# Product and Process Change Notice

<b>PCN No.</b>	PCN03058	<b>PCN Date</b>	11/9/2022	<b>Effective Date</b>	4/25/2022
<b>Title</b>	<b>BGA Tray Change from UBOT to Hwa Shu</b>

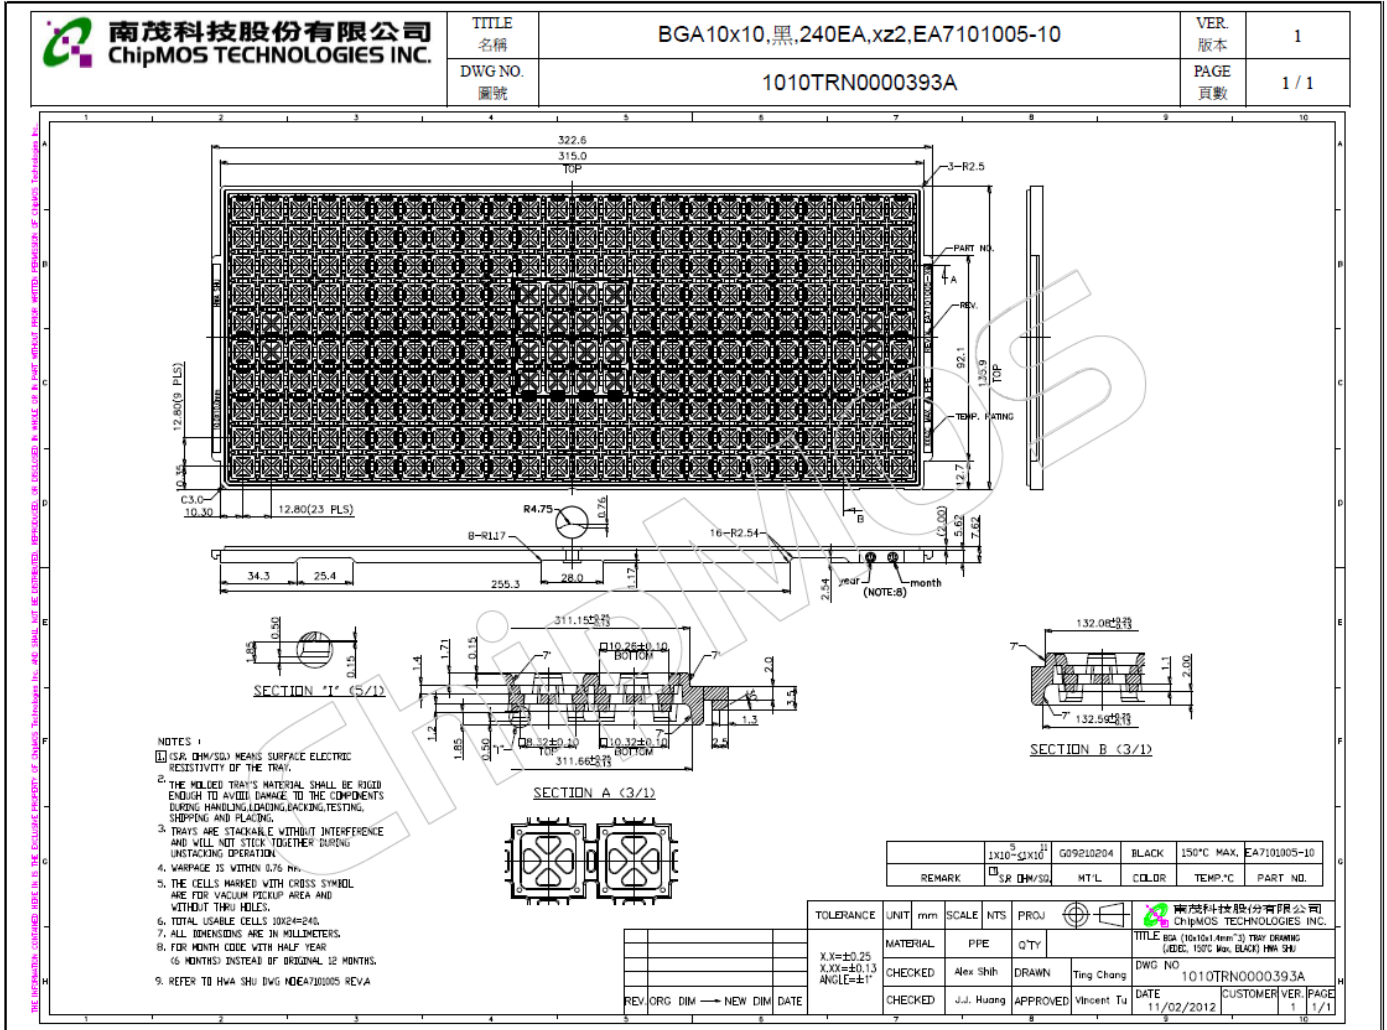
Hwa Shu Dimensions –(New) BGA TRAY 10 x 10mm 240 10 x 24 10mm-10x24 See attached below (JEDEC)

Ubot BGA Tray Dimensions – (old) 10x10 184 1.5x8x23 See attached below (JEDEC)
